Section 92 Response Attachments

Attachment 6 - Traffic

11117-4
12 December 2012

**Watercare Central Interceptor
Transport Response to Section 92 Request for Further Information**

38.v2

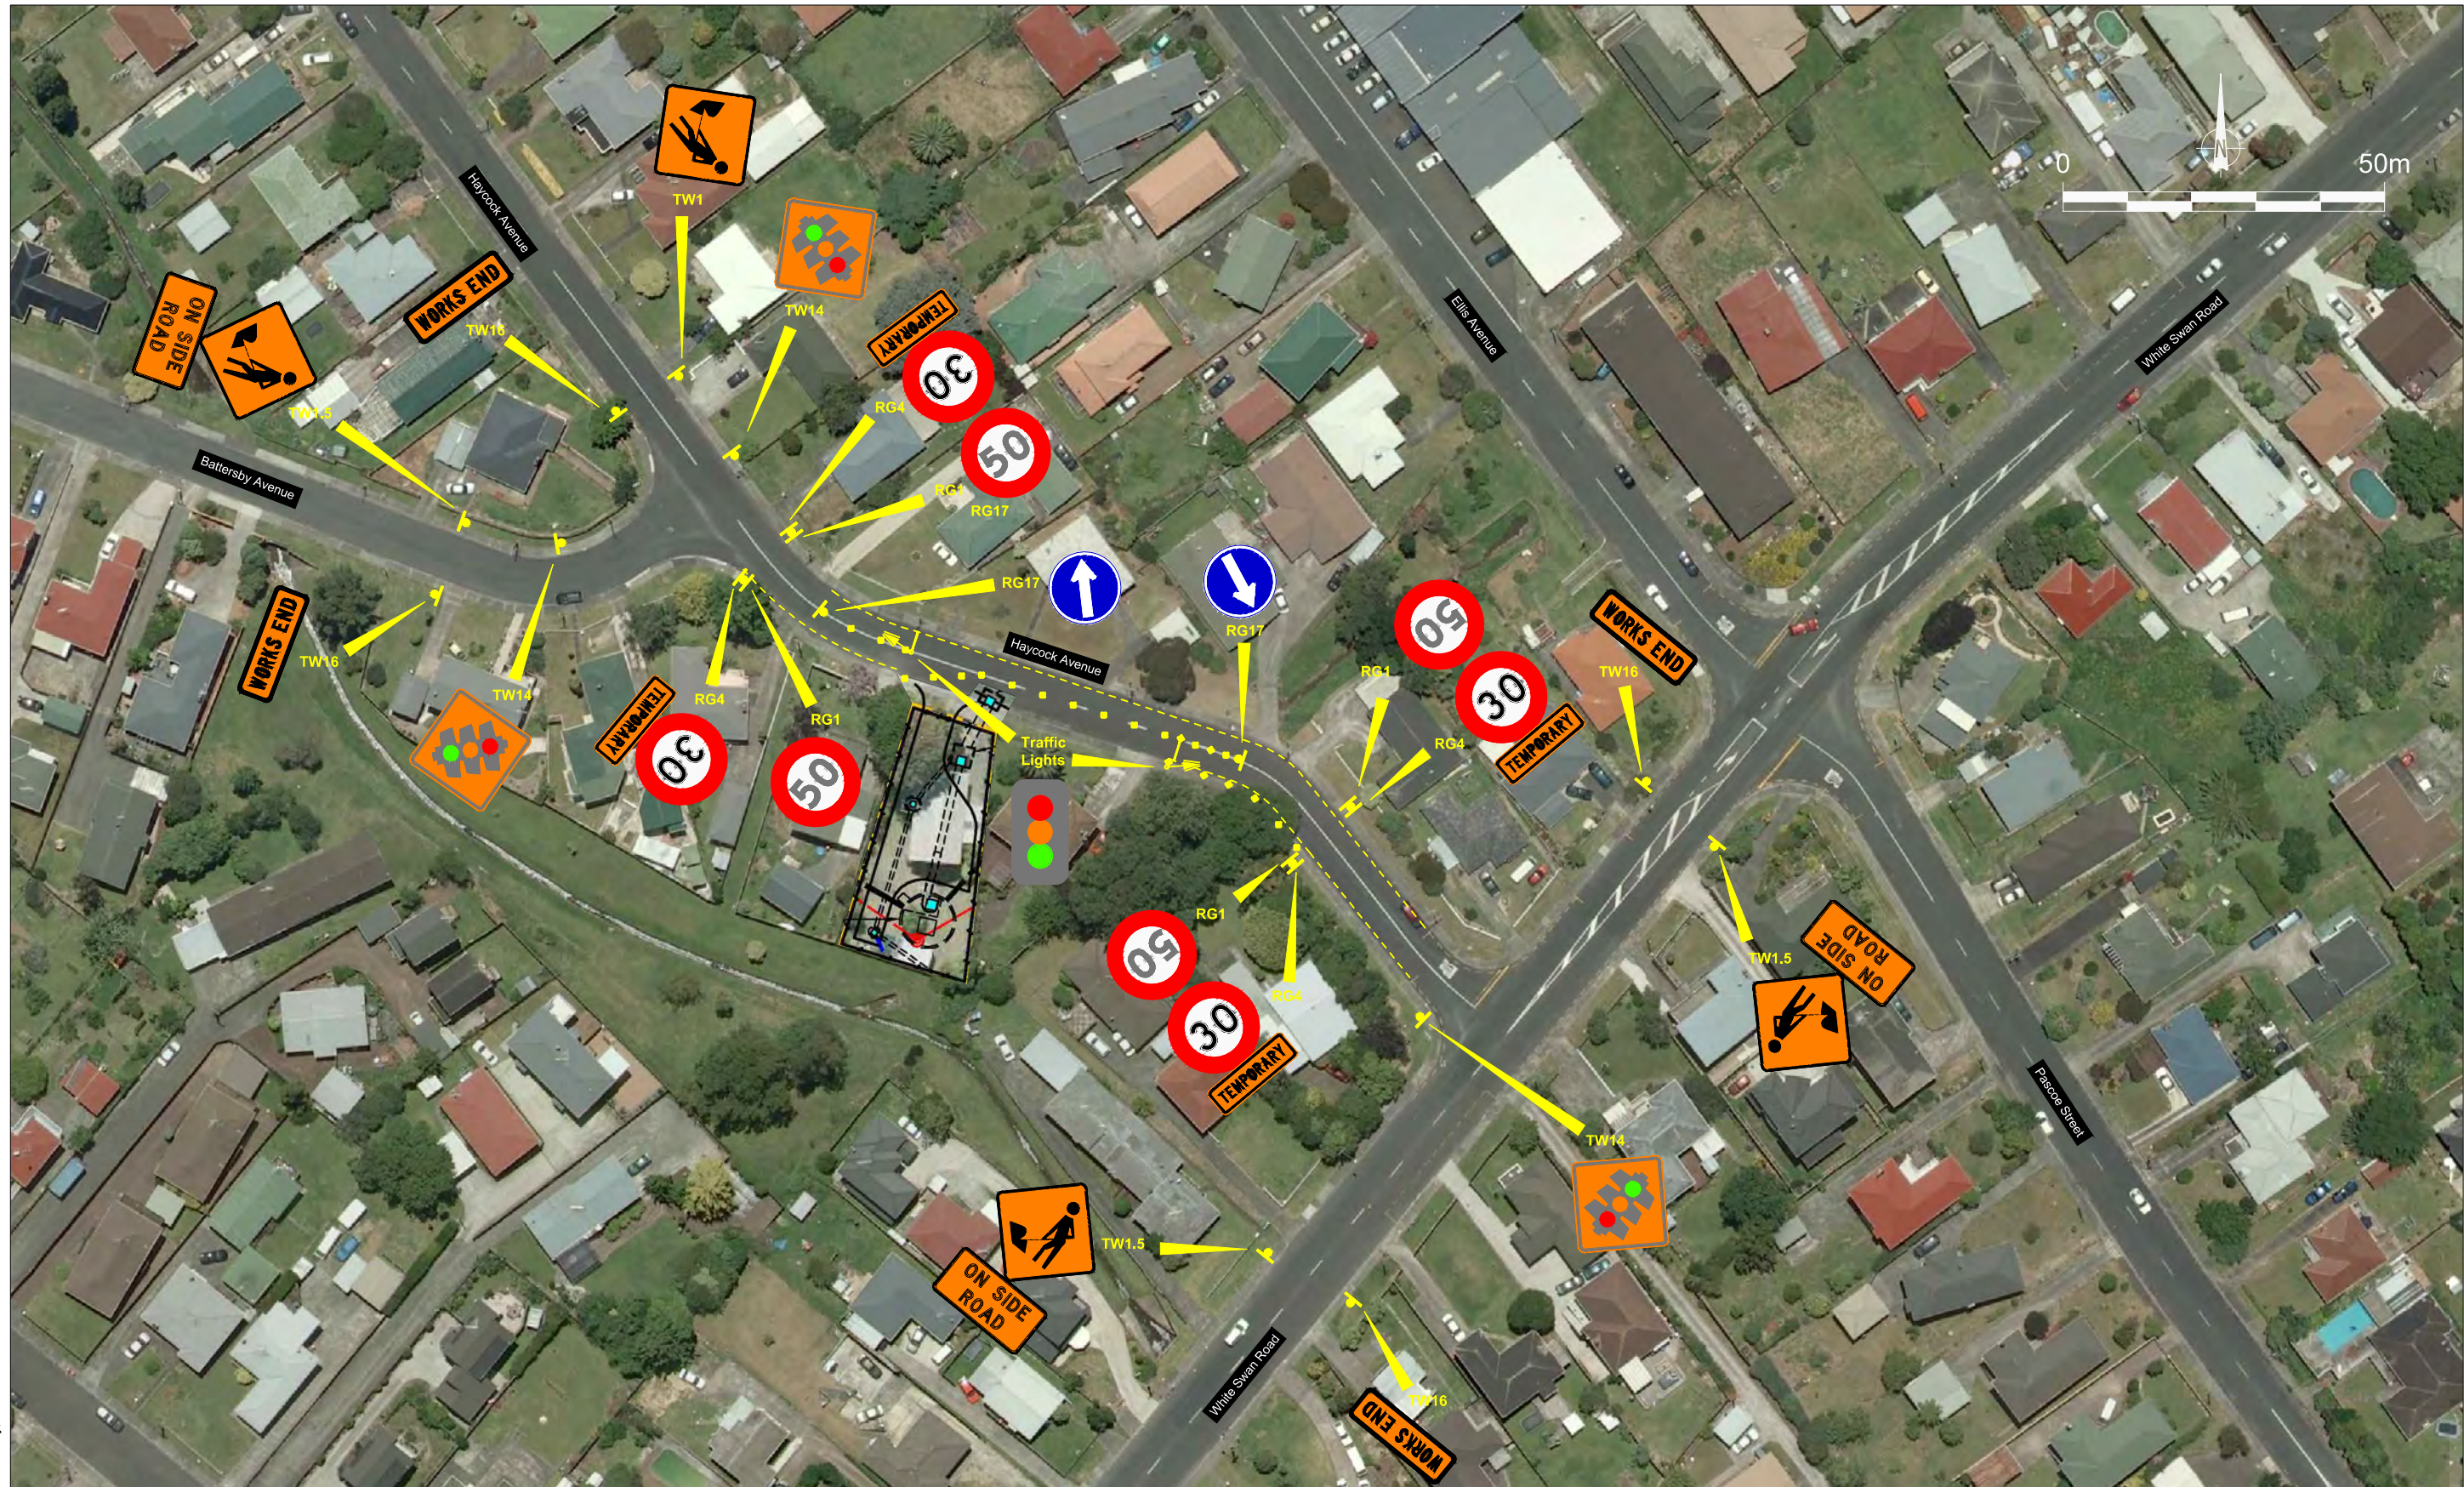
- *Detail is required as to the provision of access for the neighbouring properties when lane closures are in place.*

Revised tracking curves are shown on Figure 38 (version 2) of Appendix A in this response showing the correct truck movements accessing the site, which will be restricted to left-in/left out without the lane closure.
